INDESIT company

Model type:
AML89EU

Commercial code:
F030596

n1040325: New shock absorber fixing system with pin

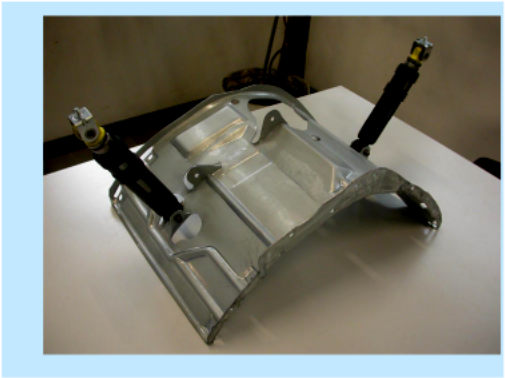
From serial no. 40427.0001, shock absorbers have been fixed to the tank unit cradle with two 11 mm pins code C00110163 (see fig. 01 and 02 enclosed) in place of the 8 mm screws code 093750 and relevant locking nuts code 030443, on all washing

machines and dryers produced in the Comunanza factory.
The items affected by this modification are:
1) The cradles have the same Service code, as they can be used in place of the new ones after widening the shock absorber fixing holes to a diameter of 10 mm.
Code 093848 - Tank unit cradle 46 lt
Code 093878 - Tank unit cradle 40 lt.
2) The new shock absorbers, with fixing bushing having no s/steel spacer, are not managed as they are interchangeable with the premodified items (make sure they are CIMA type, as the managed items), fixed with M8 screws code 093750 and related locking nut code 030443 (see figs. 05 and 06).
Code 093884 - Shock absorber 80 N
Code 093885 - Shock absorber 100 N

To remove the shock absorber from the tank, first extract the pin with a few hammer taps (see fig.03) until it is aligned with the tank bracket and then pull it out with a pair of pliers (see fig. 04).
(To refit the shock absorber use a new pin. Insert the pin until the toroidal edge is aligned with the bracket.)

Fig. n10402231

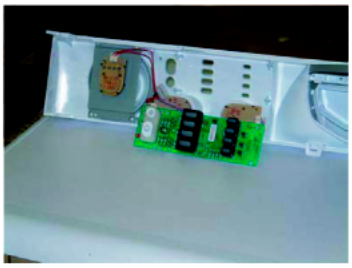
From serial no. 40429.0001, models AVL, AVXL, AVSL, AML have been equipped with a new panel with well holes for the ON/OFF and RESET buttons and flush plastic light diffusers in place of the projecting siliconed ones (see picture n10402231

Fig. n10402232

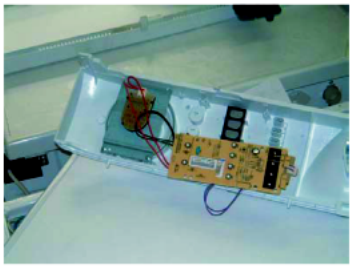
Fig.02). These features determine whether an appliance is modified or premodification.
The modification has also involved the electronic card whose panel and display communication connectors are on the left and not at the back (see picture n10402232 Fig.2).

n1040342: New balancing system for washer-dryer models with spin cycle up to 1200 rpm.

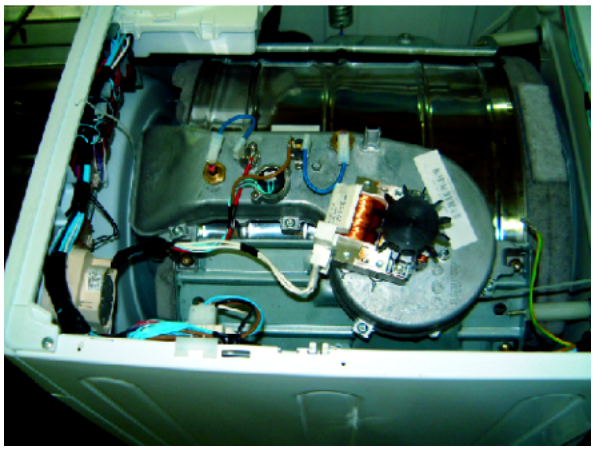
From serial number 41026.0001, all WIDL, AML, AMD washer-dryer models up to 1200 rpm produced in the Comunanza plant are equipped with a new balancing system for the mobile assembly (see fig.001).
The modification involves the following parts, which are not interchangeable with their premodification equivalents:

C00114386 - REAR COUNTERWEIGHT WD 6 kg;
C00114388 - DRYER KIT BLOWER BODY S/N 41026.0001;
C00114390 - BLOWER BODY FIXING SCREW SN 41026 M8X25S.P.P.
C00114487 - REAR COUNTER-WEIGHT FIXING SCREW M8X32TE.
In preparation for this modification, drum spiders already prearranged with fixing holes for the rear counter-weight (see attached image) have been installed on production appliances and included in the spare parts programme.

Fig . 001

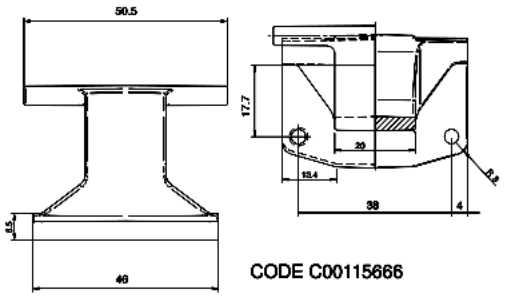
From serial no. 50207.0001, all Ariston models produced in the Teverola factory (see table 001 attached) with industrial code (given on the rating plate) starting with 46, have been equipped with a Zamac hinge with 150° opening angle, code C00115666 (see Fig.001).
This modification has involved the introduction of the following items:

Code C00115670 - Complete door EVOII 150° white 27 with standard glass;
Code C00115674 - Complete door EVOII 150° white 27 with long glass;
Code C00115667 - EVOII body for 150° hinge white 27;

Fig . 001

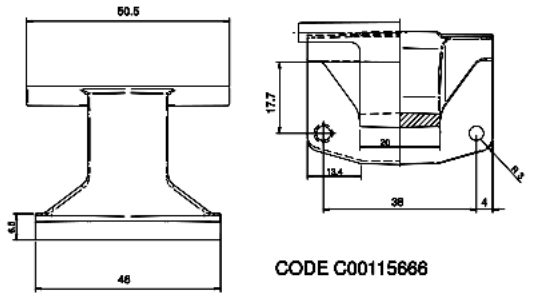
From serial no. 50207.0001, all Ariston models produced in the Comunanza factory (see table 001 attached) with industrial code (given on the rating plate) starting with 80, have been equipped with a Zamac hinge with 150° opening angle, code C00115666 (see Fig.001).
This modification has involved the introduction of the following items:

Code C00115670 - Complete door EVOII 150° white 27 with standard glass;
Code C00115674 - Complete door EVOII 150° white 27 with long glass;
Code C00115668 - Complete door EVOII 150° silver with standard glass;
Code C00115673 - Complete door EVOII 150° silver snella standard glass;
Code C00115662 - EVOII body for 150° hinge white 27
Code C00115663 - EVOII body for 150° hinge silver 27
Code C00115664 - Snella EVOII body for 150° hinge white 27
Code C00115665 - Snella EVOII body for 150° hinge silver

n4008f00: Thermic link wire removed on three-phase motor

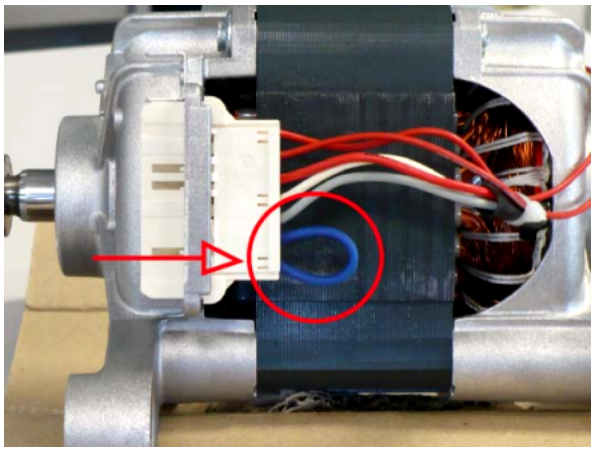
Attention!
When you assist the premodification models using the new motor code you MUST use the thermic link wire code C00265838.

In the attached image you can see the fixing of thermic link wire in the motor therminal box.
